SUBJECT: Submits response to NRC 990916 telcon RAI re 98-GO-0005,
request for relief from requirements of ASME Boiler &
Pressure Vessel Code,Section XI.

Request for Relief from the Requirements of the
ASME Boiler and Pressure Vessel Code, Section XI
Duke Energy Corporation Serial Number 98-GO-0005
Response to NRC Request for Additional Information

By letters dated September 29, 1998 and April 26, 1999, Duke Energy Corporation submitted Request for Relief 98-GO-0005. In a telephone conference call held on September 16, 1999, the NRC requested Duke to provide additional information on 98-GO-005. In response to this NRC request, the information listed below is provided.

**EXAMINATION VOLUME FOR STEAM GENERATOR
NOZZLE-TO-SAFE END WELDS**

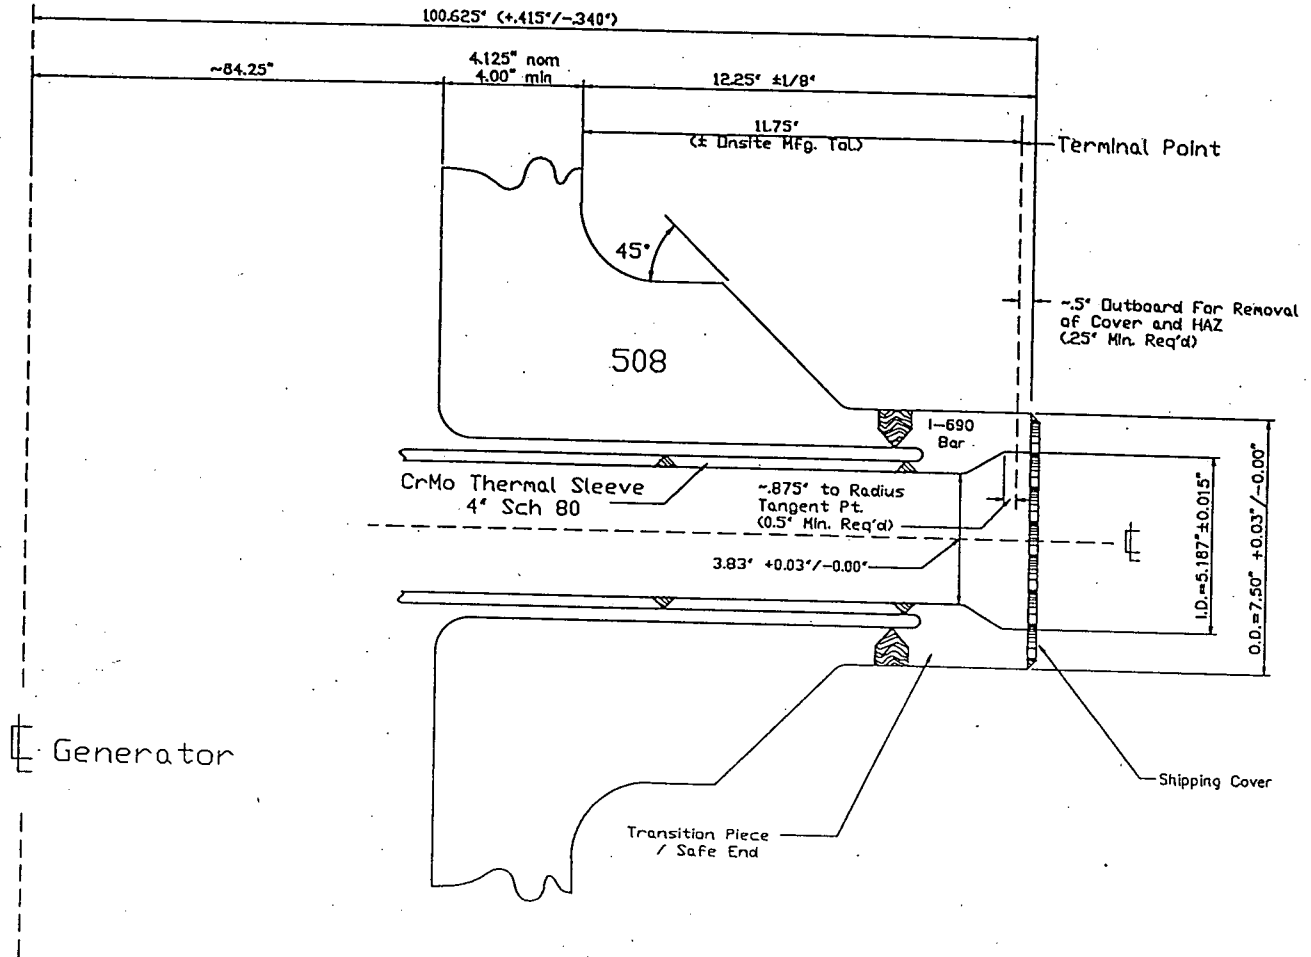
Axial scan from safe end side only
